City of Boise
ADA Assessment

Lowell Pool

Report #TO20-B004

Appendix A – Lowell Pool

ID:
3775

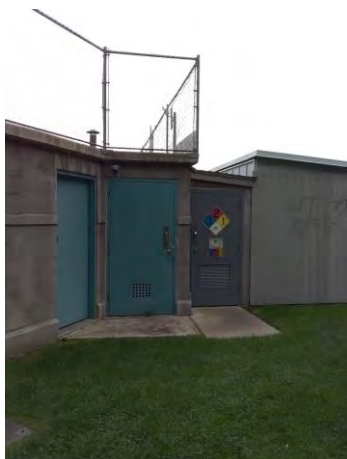
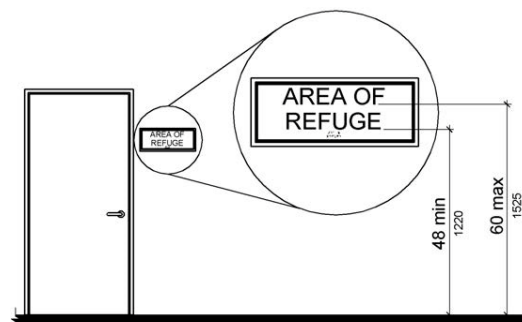
2010 ADA Standards for Accessible Design Codes: §216.2, §703

There is no tactile sign identifying the permanent room.

Install tactile signage on the latch side of the doorway at a height of 48" minimum to 60" maximum above the floor, identifying room by name or room number.

Signs shall be Braille with raised lettering and should be placed on the wall in the center of an 18"x18" clear floor space.

ID:
4462

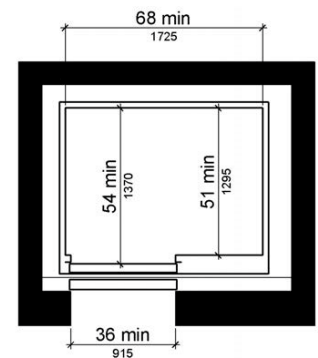
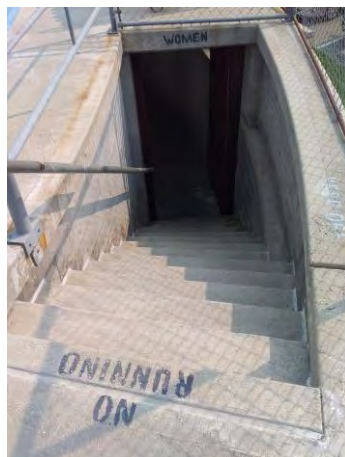
2010 ADA Standards for Accessible Design Codes: §407

The stairs are not accessible for persons in wheelchair.

Construct a 60"x60" elevator with a 36" wide door connecting the pool deck to the proposed accessible locker rooms. Controls shall be installed at 48" maximum above the floor and emergency controls at 38" above the floor. Ensure car position indicators provide verbal announcements of stops. Floor designations shall be provided on both hoistway door jambs and a tactile star shall be provided on the main entry

ID:
3048

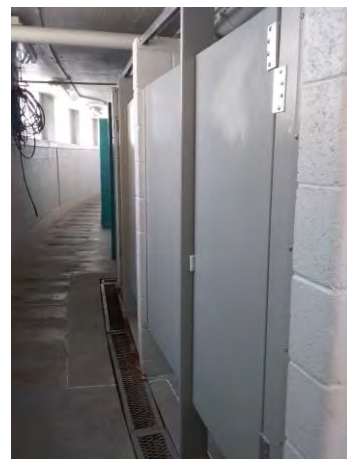
2010 ADA Standards for Accessible Design Codes: §308, §604, §608

There is not an accessible shower or stall provided in the men and women's locker room. The shower dimensions do not meet the requirements for a transfer type shower at 43"x31". The stalls provided are too small to be accessible.

Due to the historic nature and limited space of the facility, consider constructing an adjacent facility containing an accessible locker rooms, showers, and restroom stalls.

Elements in the accessible shall comply with Section 2.9 of the Lowell Report.

ID:
3609

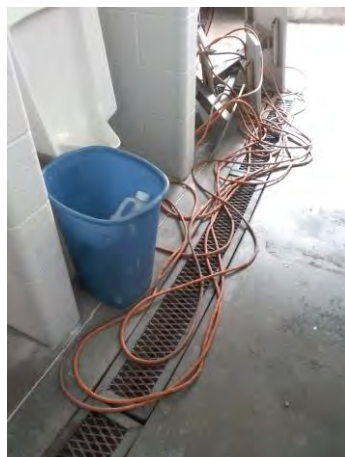
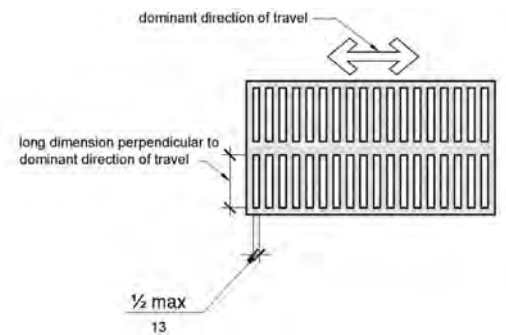
2010 ADA Standards for Accessible Design Codes: §302.3

The grates in the men and women's locker room path are not stable.

Replace the grates throughout the locker rooms and ensure that they are secure and stable. Ensure that the openings in the grate is less than 0.5”.

ID:
3412

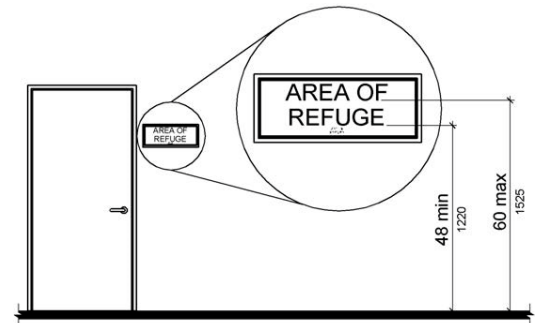
2010 ADA Standards for Accessible Design Codes: §216.2, §703

There is no tactile sign identifying the permanent room.

Install tactile signage on the latch side of the doorway at a height of 48" minimum to 60" maximum above the floor, identifying room by name or room number.

Signs shall be Braille with raised lettering and should be placed on the wall in the center of an 18"x18" clear floor space.

ID:
3254

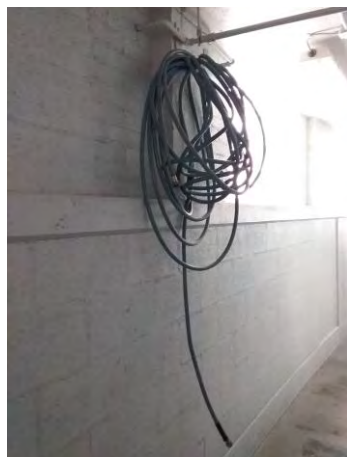
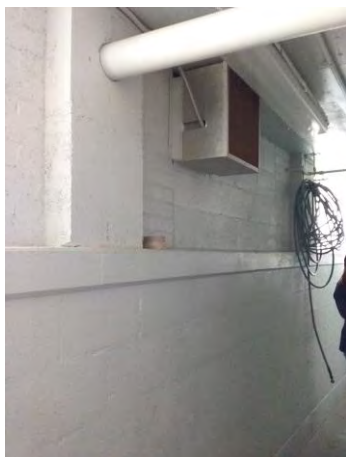
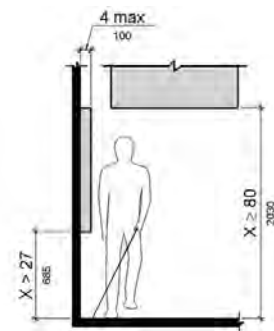
2010 ADA Standards for Accessible Design Codes: §307.2

The hose protrudes 6" into the circulation space at 63" above the floor.
The air conditioning unit protrudes 7" into the circulation space at 78" above the floor.

Recess the hose and air conditioning unit so they protrude a maximum of 4", lower them so the bottom edge is 27" maximum above the floor, or place a cane detectable object beneath it.

ID:
3307

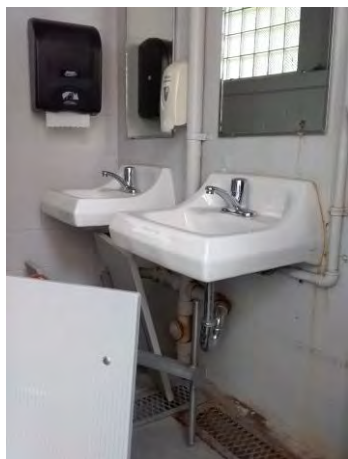
2010 ADA Standards for Accessible Design Codes: §606.5

The pipes under the sink are not covered.

Wrap the pipes beneath the sink with soft protective wrap or plastic.

ID:
3472

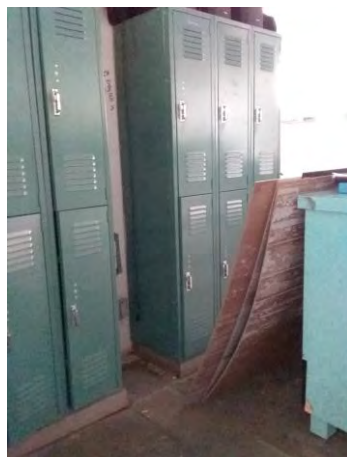
2010 ADA Standards for Accessible Design Codes: §304.3.1

There is not an adequate turning space in the men's locker room.

Expand the space to provide a Circular or T-Shaped turning space. The circular turning space shall have a minimum diameter of 60".

The T-Shaped space shall be 60" square minimum with arms and base 36" wide minimum. Each arm shall be clear of obstructions 12" minimum in each direction. The base shall be clear of obstruction 24" minimum.

ID:
3242

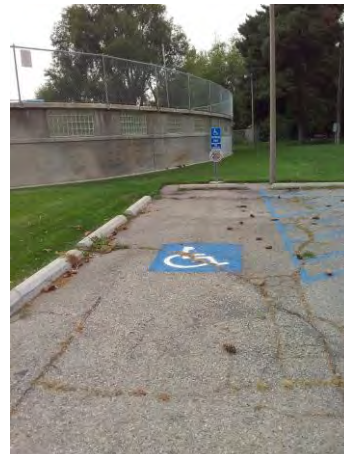
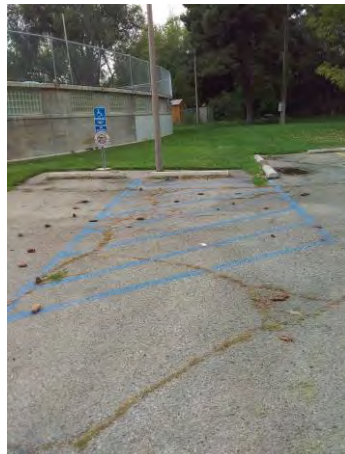
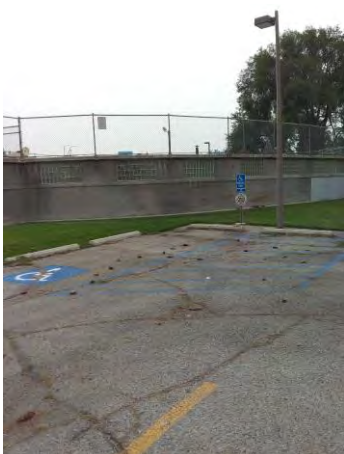
2010 ADA Standards for Accessible Design Codes: §502.6

The accessible parking sign is 46" above the floor.

Remount the accessible parking sign at a minimum height of 60" above the ground.

ID:
3243

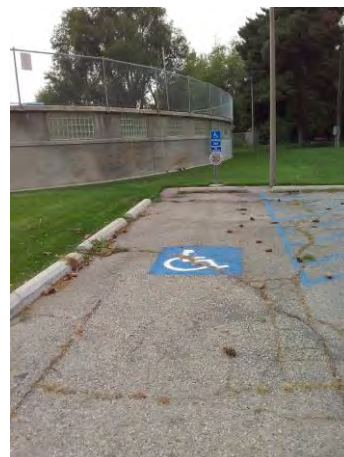
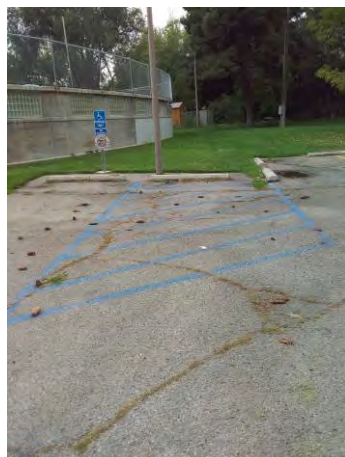
2010 ADA Standards for Accessible Design Codes: §303.2

There is a change in level greater than 0.25" in the accessible parking space and access aisle creating tripping hazards.

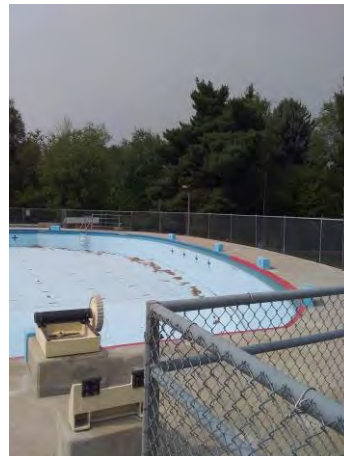
2010 ADA Standards for Accessible Design Codes: §242.2, §1009

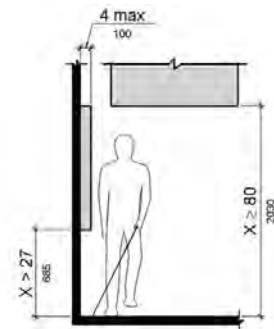
2010 ADA Standards for Accessible Design Codes: §307.2

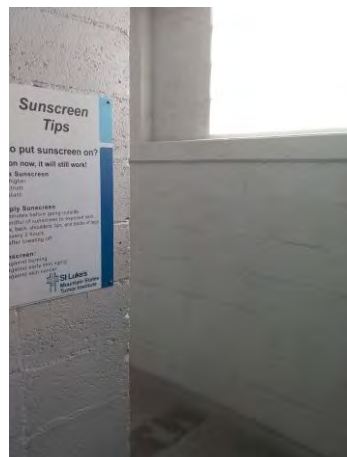
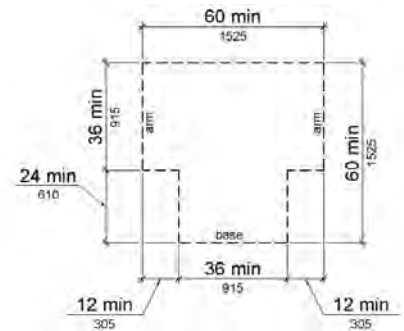
2010 ADA Standards for Accessible Design Codes: §304.3.1

There is not an adequate turning space in the check-in area.

Expand the space to provide a Circular or T-shaped turning space. The circular turning space shall have a minimum diameter of 60".

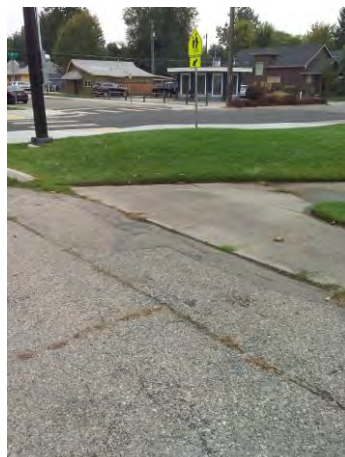
2010 ADA Standards for Accessible Design Codes: §403.3

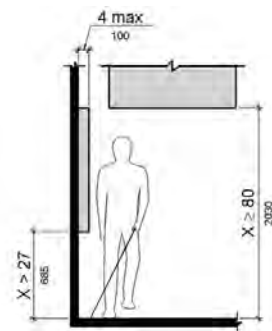
2010 ADA Standards for Accessible Design Codes: §307.2

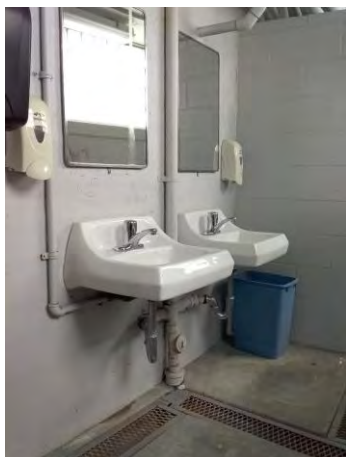
2010 ADA Standards for Accessible Design Codes: §606.5

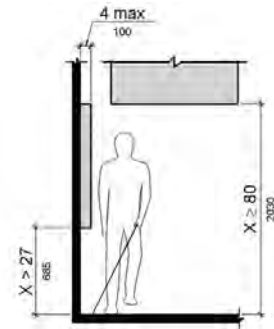
2010 ADA Standards for Accessible Design Codes: §307.2

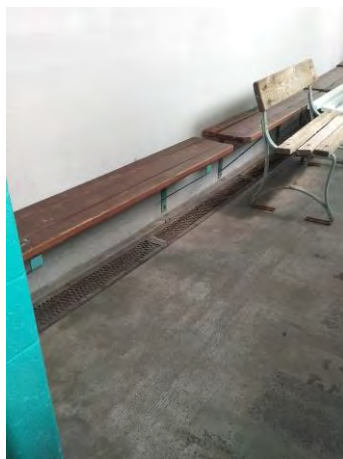
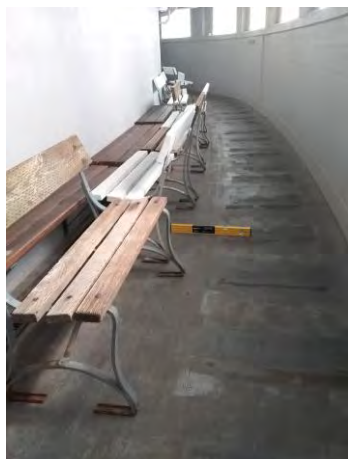
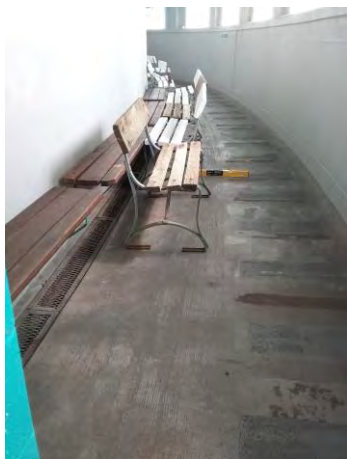
2010 ADA Standards for Accessible Design Codes: §403.3
